MONTICELLO NUCLEAR GENERATING PLANT  
Docket No. 50-263 License No. DPR-22

Request for Exemption from Certain Requirements of  
10CFR50, Appendix J, "Primary Reactor Containment  
Leakage Testing for Water-Cooled Power Reactors"

REQUEST FOR EXEMPTION FROM CERTAIN REQUIREMENTS OF 10CFR50, APPENDIX J

Figure 1. Torus Spray Containment Penetrations

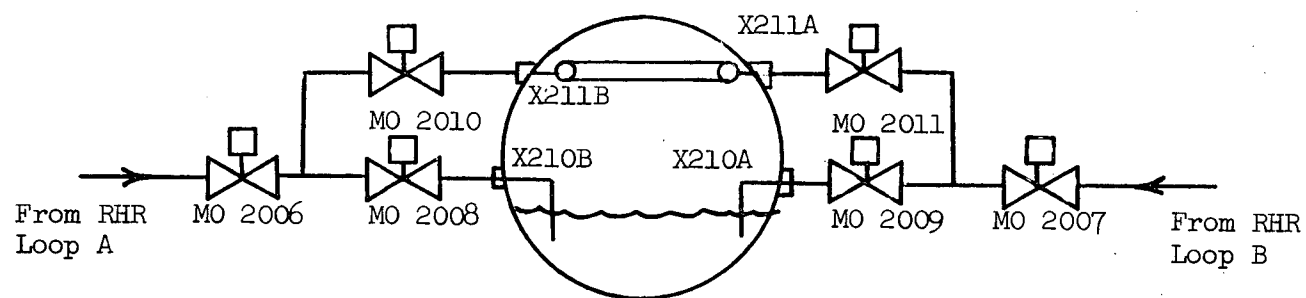
Section III.C.1, under the definition contained in Section II.H.3, can be construed to require testing of the Loop A and Loop B Suppression Chamber Spray valves (Figure 1). No provision for conducting local leakage tests was provided in the original plant design.

We request that these valves be excluded from Type C testing.

These valves are normally closed, remote-manual motor operated valves. They can be intermittently opened by the Control Room Operator to reduce the temperature and pressure in the torus during the latter stages of a loss of coolant accident. Both valves are located outside of containment.

These lines would be pressurized by the RHR pumps during all stages of the accident. This pressure is well above the peak suppression chamber pressure following a loss of coolant accident preventing any outleakage of the suppression chamber gaseous atmosphere. There is no single active failure which could prevent pressurization of these lines by the RHR pumps.

Since the Torus Spray lines cannot constitute a containment leakage path, testing of the isolation valves in these lines is unnecessary.

Figure 2. Drywell Spray Containment Penetrations

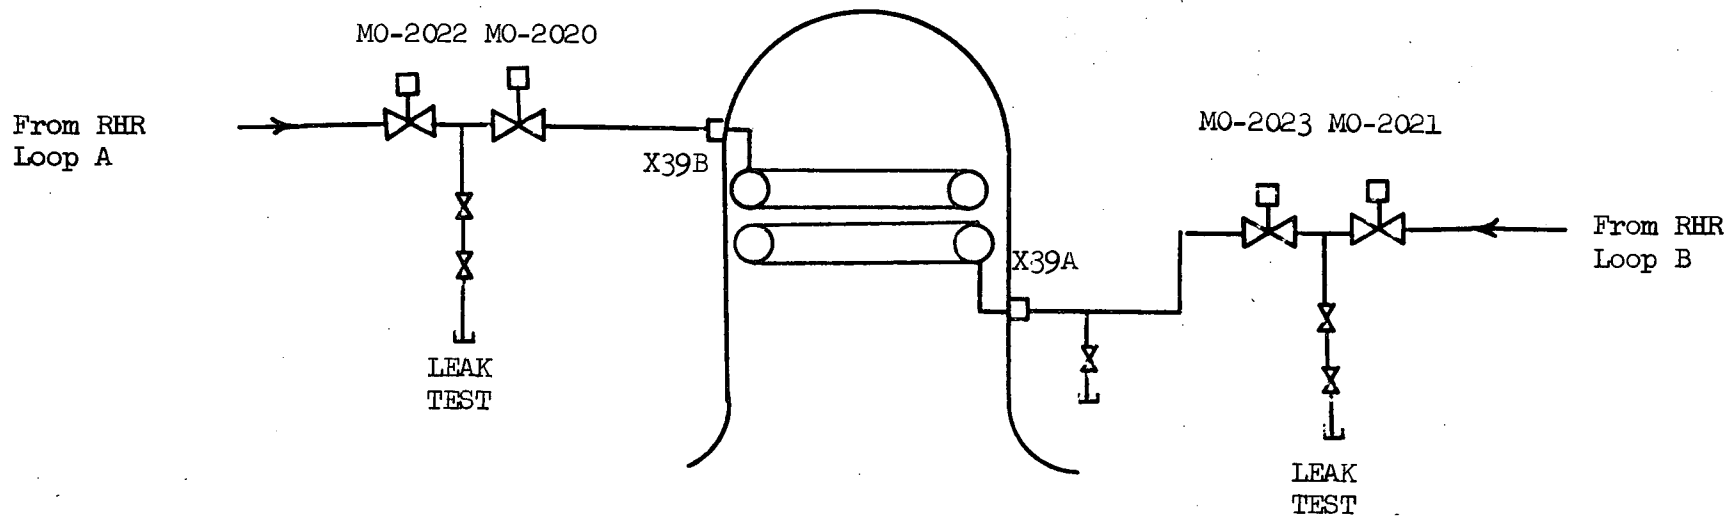
We request that we be permitted to test all of the following penetrations, except X-39A and X-39B, with test pressure in the reverse direction. There is no provision for testing these penetrations in the correct direction. We request that we be exempted from the requirement to test penetrations X-39A and X-39B.

The valves in penetrations X-39A and X-39B are normally closed, remote-manual motor operated valves. They can be intermittently opened by the Control Room Operator to reduce the Temperature and pressure in the drywell during the later stages of a loss of coolant accident. X-39A and X-39B would be pressurized by the RHR pumps during all stages of the accident. This pressure is well above the peak drywell accident pressure preventing any outleakage of the drywell gaseous atmosphere. There is no single active failure which could prevent pressurization of these lines. Since these lines cannot constitute a containment leakage path, testing of the isolation valves in these lines is unnecessary (Figure 2).

Figure 3. Core Spray Loops A and B

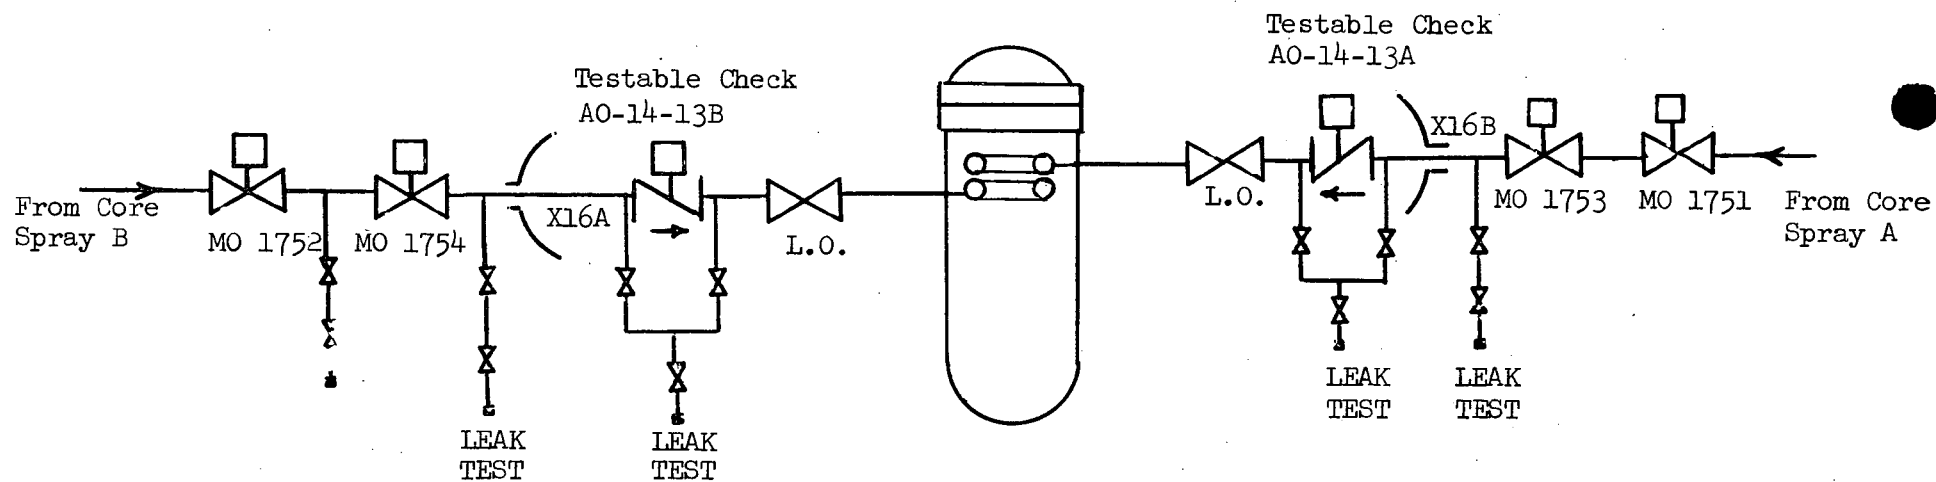
Section III.C.1, under the definition contained in Section II.H.3, can be construed to require testing of the Loop A and Loop B Core Spray Testable Check valves (Figure 3).

We request that these valves be excluded from Type C testing and that the two motor operated gate valves in each line located outside containment be subjected to Type C testing in their place.

The testable check valve in each Core Spray line was not intended to meet gas leakage acceptance criteria. These valves exhibit moderate leakage when required to seal against a low pressure gas, but are leak tight in their normal environment. These valves consistently fail to meet the individual valve Technical Specification maximum allowable leakage rate. Maintenance performed on them to meet the criteria applied to containment isolation valves involves many hours of work in an area where high radiation and contamination levels prevail. Any improvement in leak tightness is temporary.

In the event of a loss of coolant accident combined with a failure of one core spray pump to start, the potential exists for containment leakage to pass through the Core Spray line associated with the non-operating loop. Barriers to this leakage include the testable check valve located inside containment and two motor operated remote-manual valves located outside containment. In the event of a failure of a Core Spray pump, the two motor operated valves could be closed to eliminate this potential leakage path.

Provisions have been provided in the original plant design to test the two motor operated valves in each Core Spray line. This testing would be conducted in accordance with Appendix J.

Figure 4. Low Pressure Coolant Injection Loops A and B

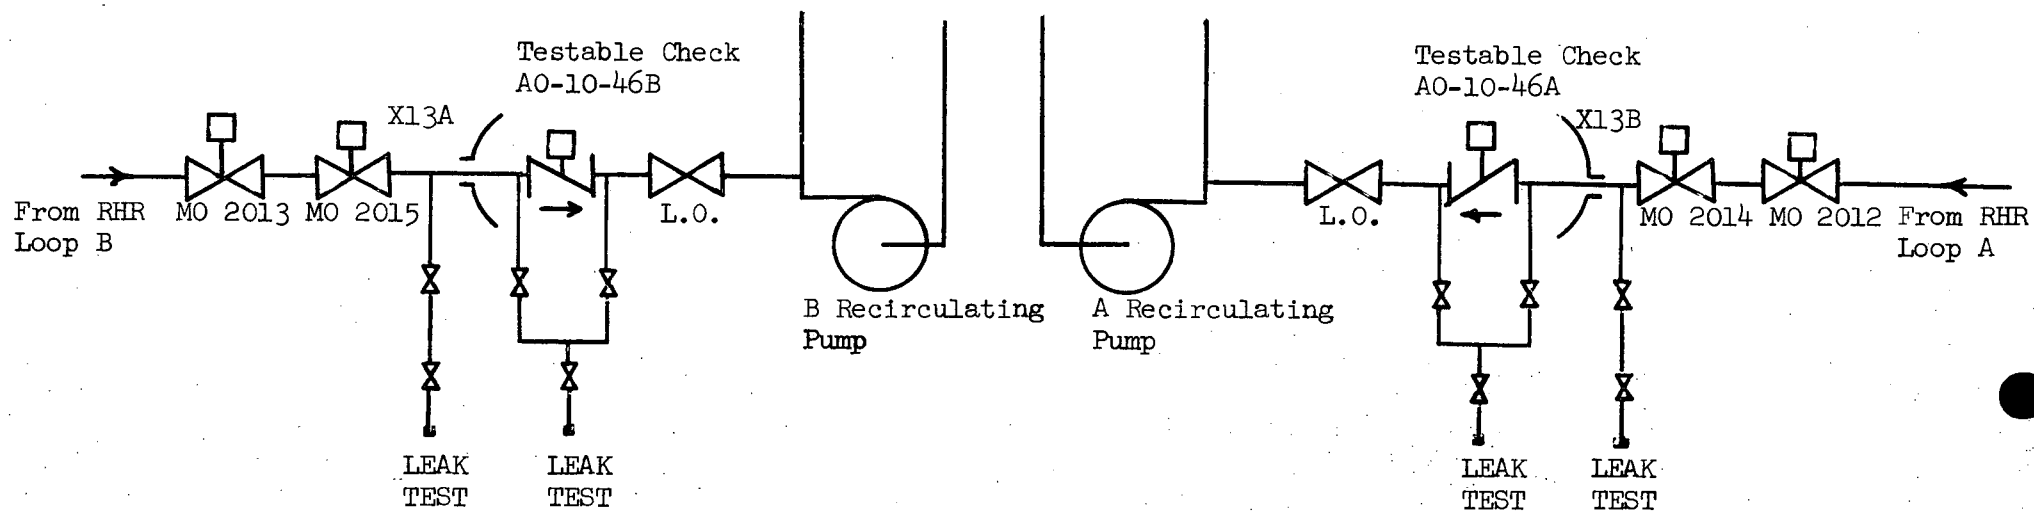
Section III.C.1, under the definition contained in Section II.H.3, can be construed to require testing of the Loop A and Loop B Low Pressure Coolant Injection (LPCI) testable check valves (Figure 4).

We request that these valves be excluded from Type C testing and that the two motor operated gate valves in each line located outside containment be subjected to Type C testing in their place.

The testable check valve in each LPCI supply line was not intended to meet gas leakage acceptance criteria. These valves exhibit moderate leakage when required to seal against a low pressure gas, but are leak tight in their normal environment. These valves consistently fail to meet the individual valve Technical Specification maximum allowable leakage rate. Maintenance performed on them to enable them to meet the criteria applied to containment isolation valves involves many hours of work in an area where high radiation and contamination levels prevail. Any improvement in leak tightness is temporary.

These lines would be pressurized by the RHR pumps in the post accident condition and would supply LPCI flow to the recirculation loops. There is no single active failure which could prevent pressurization of these lines above the calculated peak containment pressure.

It may be necessary, however, in the long term period following an accident to isolate an RHR loop to perform maintenance. Under these conditions, the barriers to containment leakage include the testable check valve located inside containment and two motor operated remote-manual (for containment isolation purposes) valves located outside containment. The two motor operated valves are closed to eliminate a potential leakage path in this situation.

Figure 5. Main Steam Line Isolation Valves

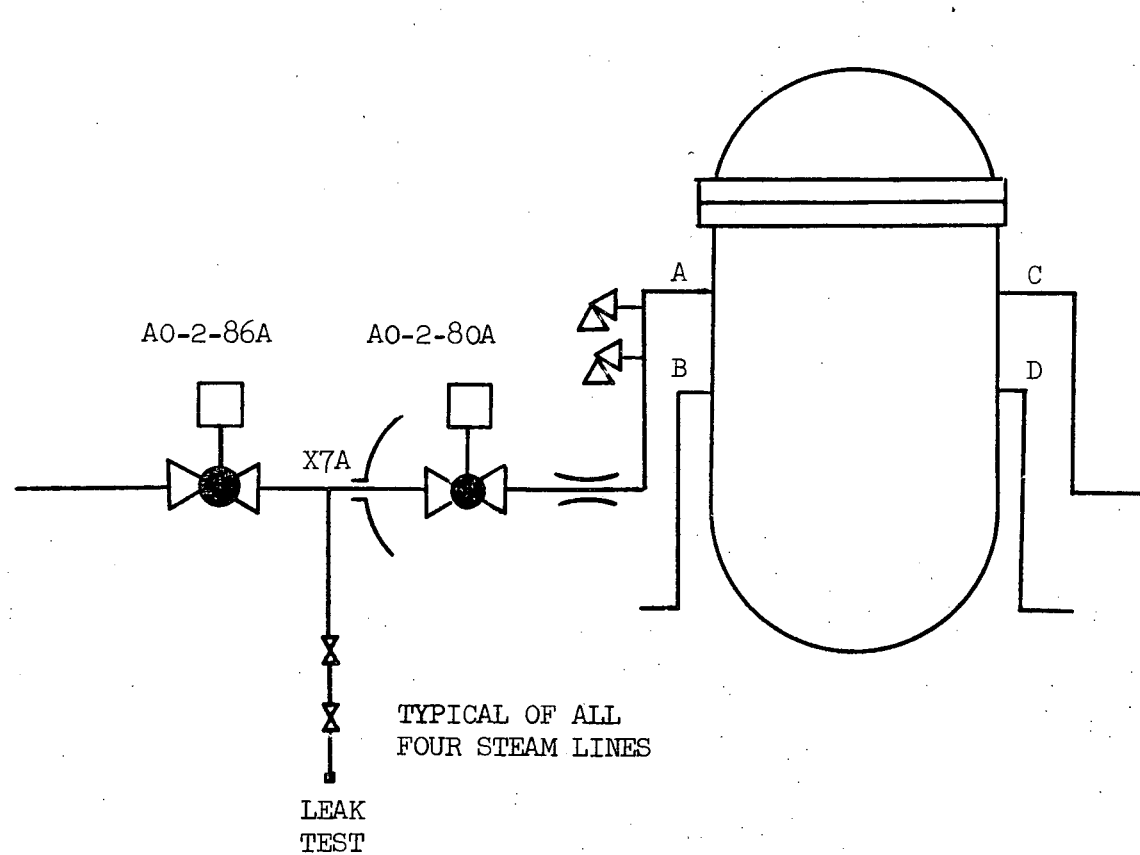
Section III.C.2 requires all Type C tests to be conducted at  $P_a$  (41 psig).

We request exemption from this requirement in the case of the Main Steam Isolation Valves (MSIV's). We ask that we be permitted to use the current 25 psig MSIV test pressure specified in the Monticello Technical Specifications.

Main Steam Isolation Valves are normally tested each refueling outage. After the vessel head has been removed, these valves must be tested by pressurizing the connecting volume between the two valves in each line (Figure 4). The inboard Main Steam Isolation Valve is subjected to test pressure in a direction that is opposite to that existing following an accident. During testing, test pressure tends to unseat the valve and can lead to an invalid measurement. For this reason, the test pressure has been limited to 25 psig for main steam isolation valve testing and the allowable leakage has been stated in terms of a 25 psig test pressure in the current Technical Specifications.
